May 20, 2002

Subject: Oconee Nuclear Station
Docket Numbers 50-269, 270, and 287
Supplement to License Amendment Request for Full-
Scope Implementation of the Alternate Source Term
Technical Specification Change (TSC) Number
2001-07

Duke Energy Corporation
Response to Request For Additional Information
Approval of Alternative Source Term Implementation

C01

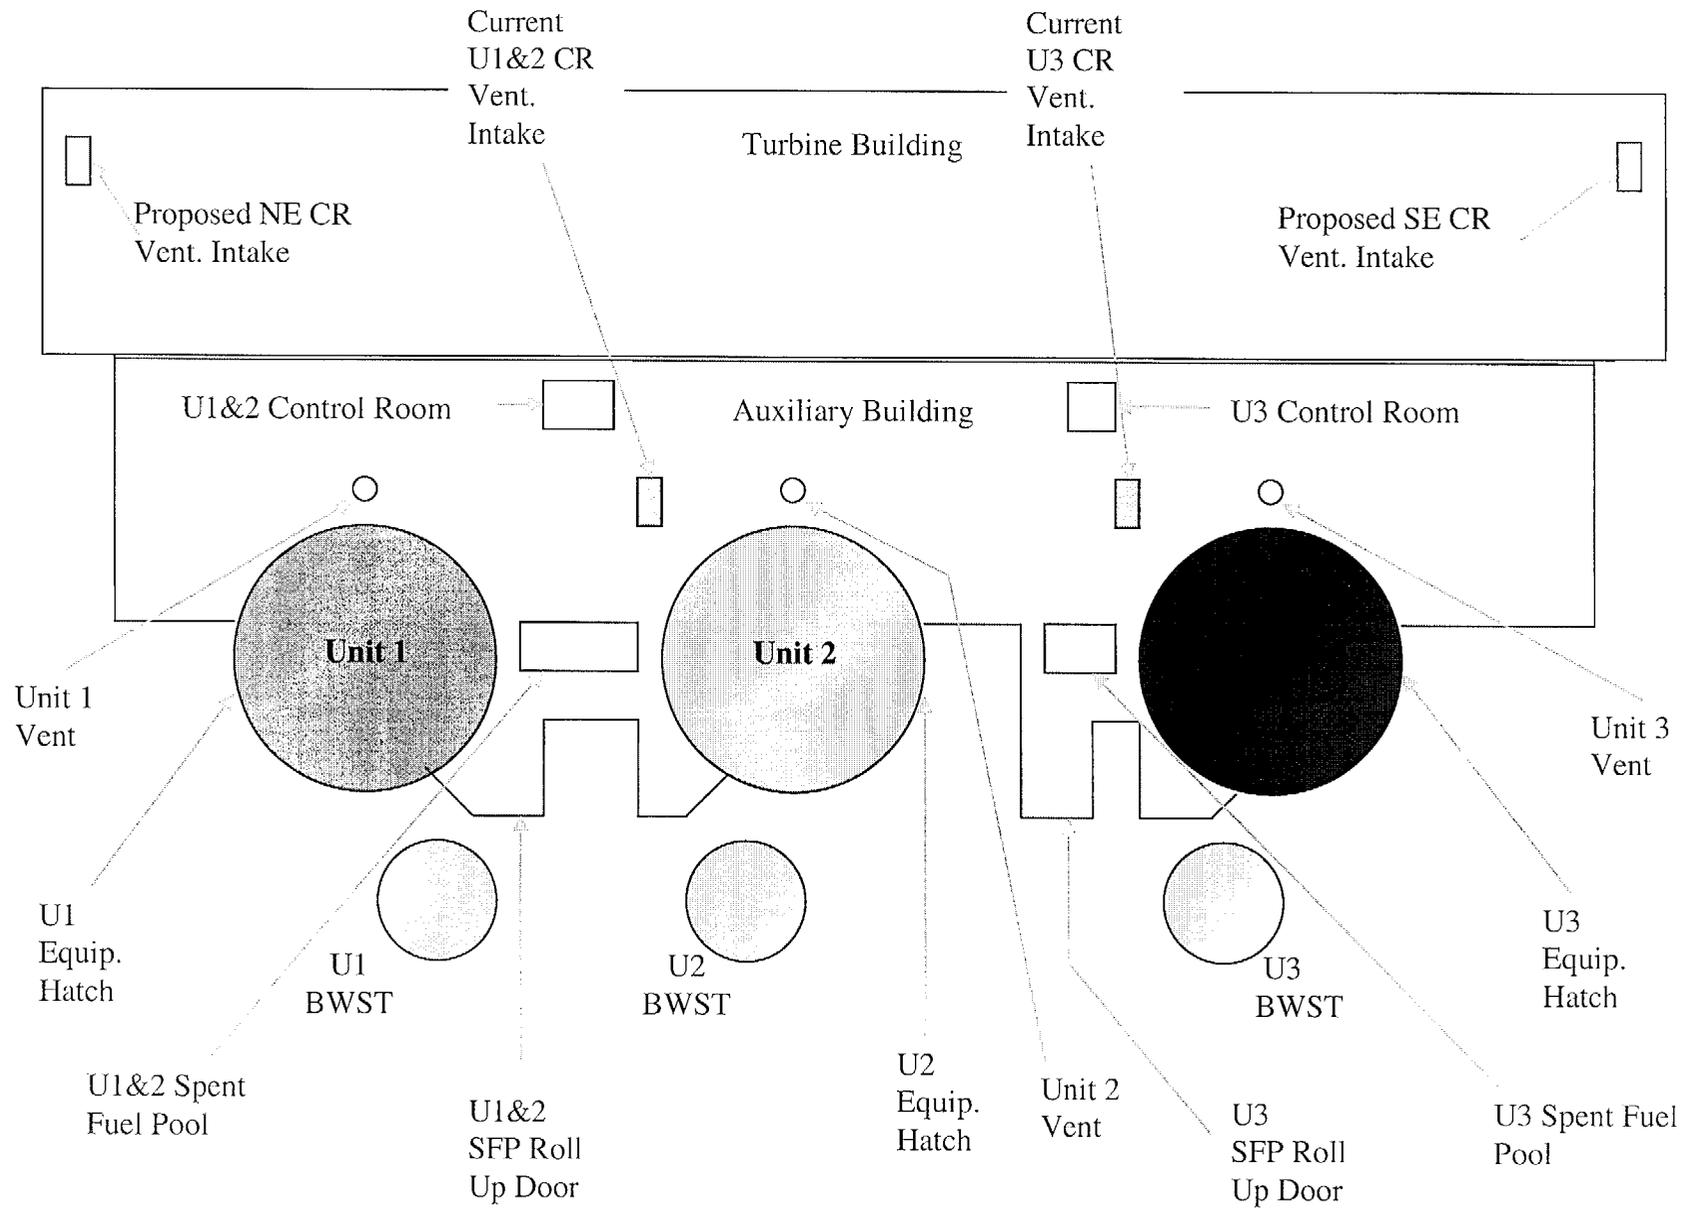
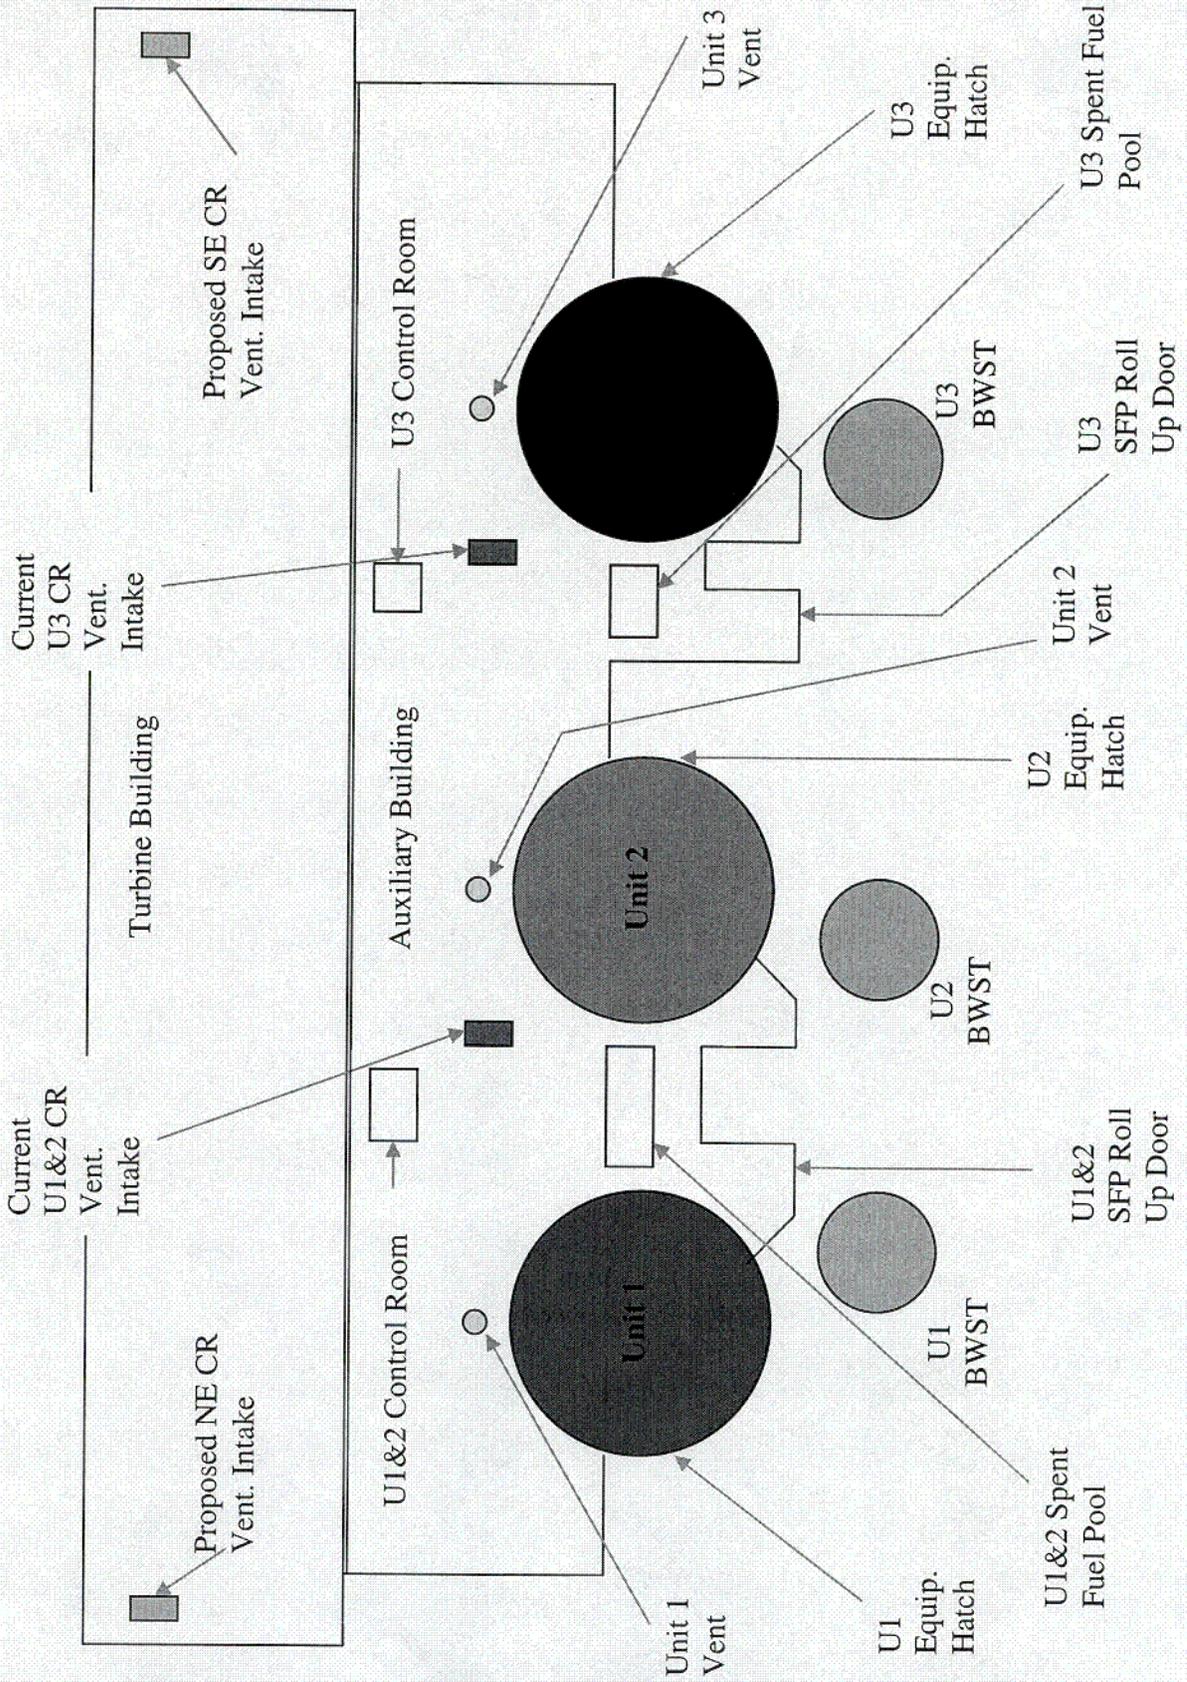
Provide drawings (or sketches) showing containment, turbine building, auxiliary building, fuel building, control room, fuel pool, containment equipment hatch, containment personal air locks, spent fuel pool roll-up door, unit vent, borated water storage tank, current control room air intake, proposed future dual control room air intakes, and source term release points for all 3 units.

The following page contains a sketch which shows layout of site buildings, location of current control room air intakes, proposed future dual control room air intakes, and source term release points for all 3 units. Note that this figure is not to scale.

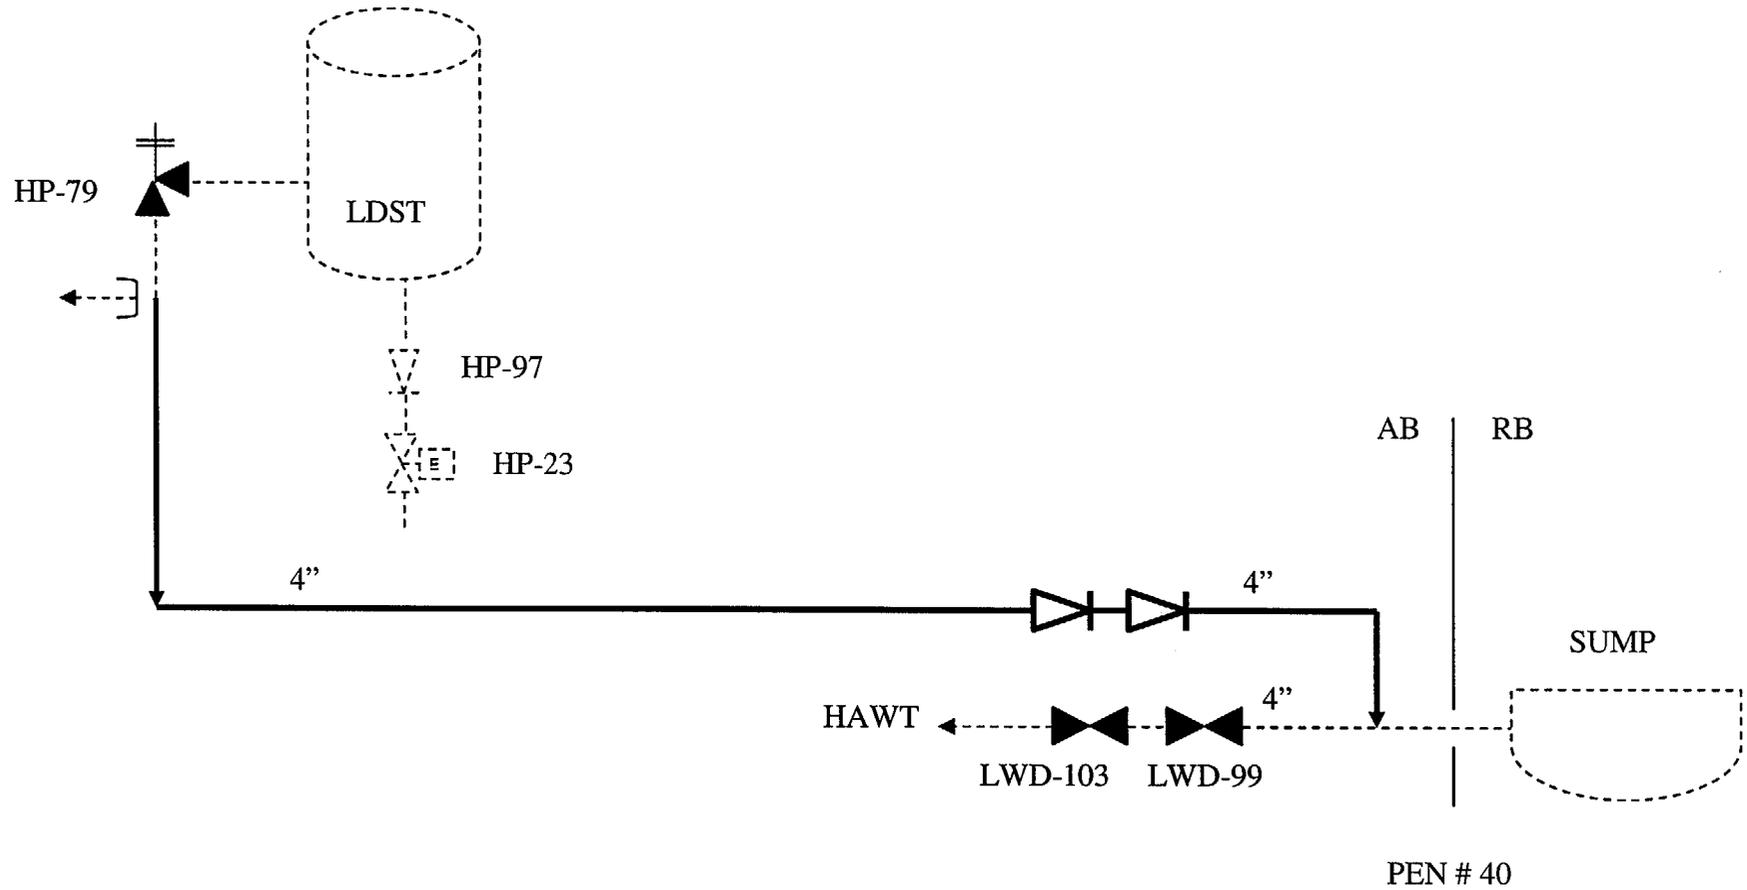
Provide P&ID for the proposed the high pressure/low pressure injection relief valve discharge to the reactor building emergency sump. Provide the schedule for this plant modification as a license commitment.

As stated in our October 16, 2001, submittal, the Letdown Storage Tank (LDST) relief valve, HP-79, currently relieves to the RC Bleed Hold-up tank, which is located in the Auxiliary Building. A modification is being implemented to route the LDST relief valve discharge to the Reactor Building Emergency Sump (RBES). The engineering design work is still in progress. The attached drawing illustrates the conceptual design. Relief valve HP-79 can be pressurized due to leakage through the following valves:

- LP-15 and LP-16 (LPI pump discharge to HPI pump suction)
- HP-23 (LDST outlet header isolation valve)
- HP-97 (LDST outlet header check valve)

Operator actions in the Emergency Operating Procedure currently prevent overpressurization of the LDST. However, Duke believes it is prudent to improve the design such that it is passive in nature. This will simplify operator actions and ensure that any leakage to the LDST is prevented from creating an offsite dose concern in that it will be routed back into the Reactor Building. This design change improves defense in depth in terms of eliminating a potential dose release pathway.

Oconee LBLOCA Sump pH Response

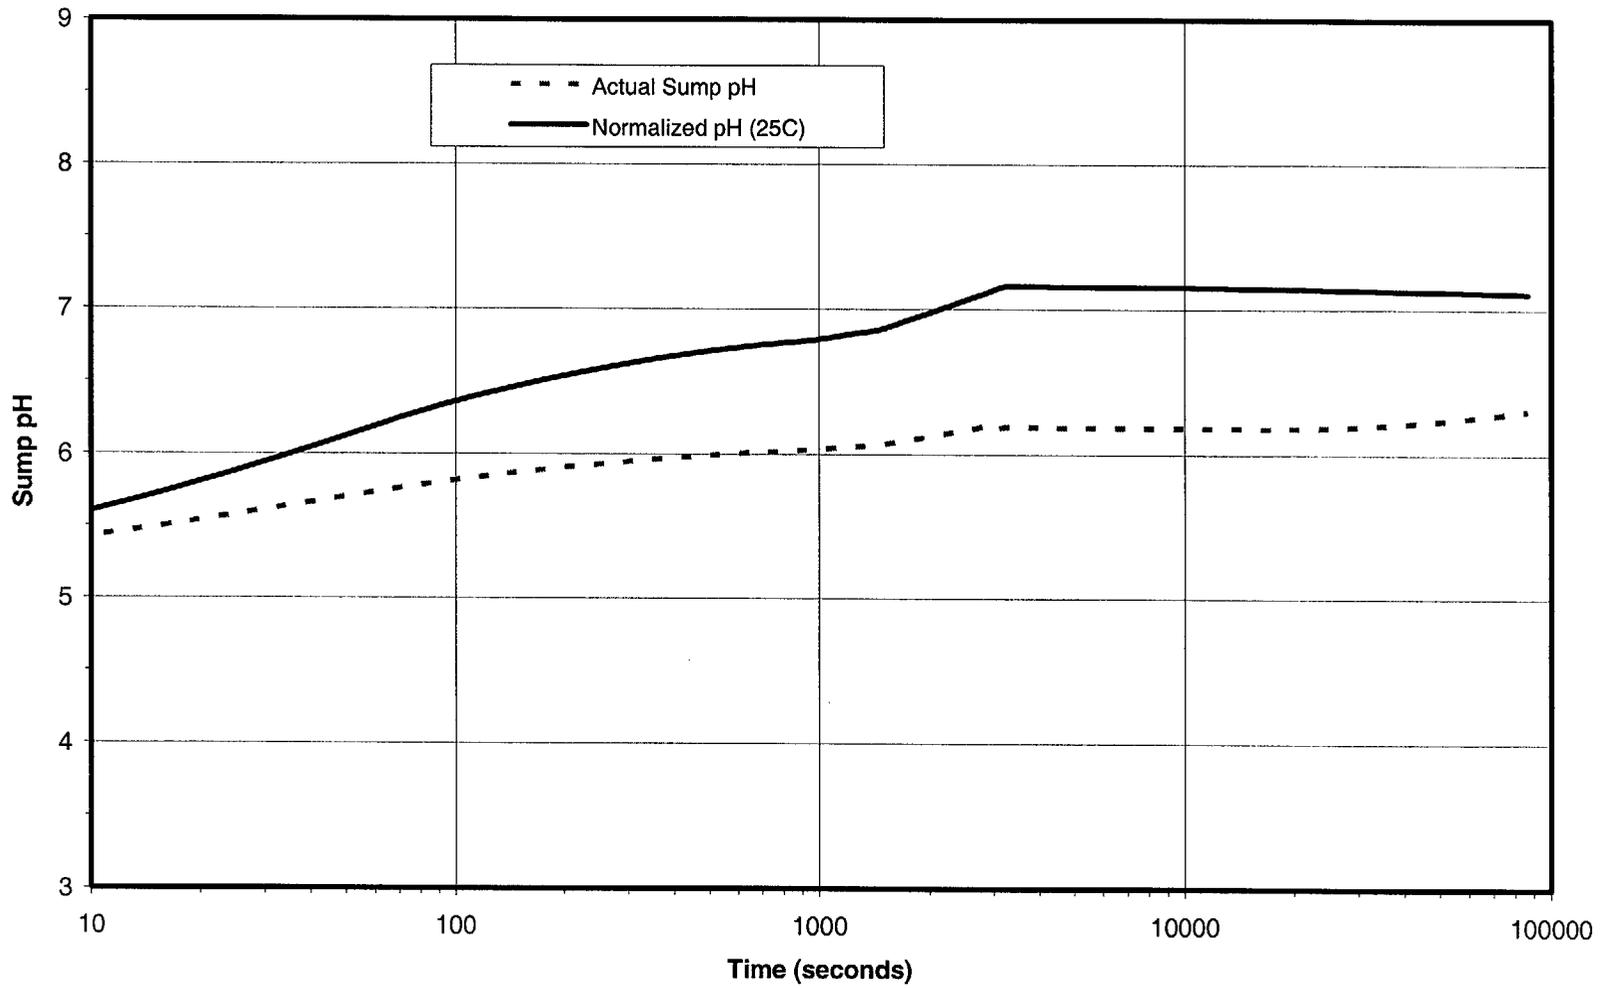
In page 10 of Attachment 3, you stated that the new passive caustic addition system will contain solid caustic or trisodium phosphate. Provide reactor building sump water pH transient calculation for the entire duration of the postulated LOCA addressing the amounts of chemical to be used, initial water pH value, water volume, chloride-bearing cable inventory, acid generation rates, radiation dose profiles, and iodine re-evolution. Provide the schedule for this plant modification as a license commitment.

The containment dose in the Reactor Building following an accident is based on data in the ONS post-accident shielding calculation. An equation representing this time dependent dose for the first 24 hours after an accident is:

$$D(t) = (3.89 \times 10^{-14}) \cdot t^3 - (7.026 \times 10^{-9}) \cdot t^2 + (5.34 \times 10^{-4}) \cdot t + 6.01 \times 10^{-1} \text{ [Mrads]}$$
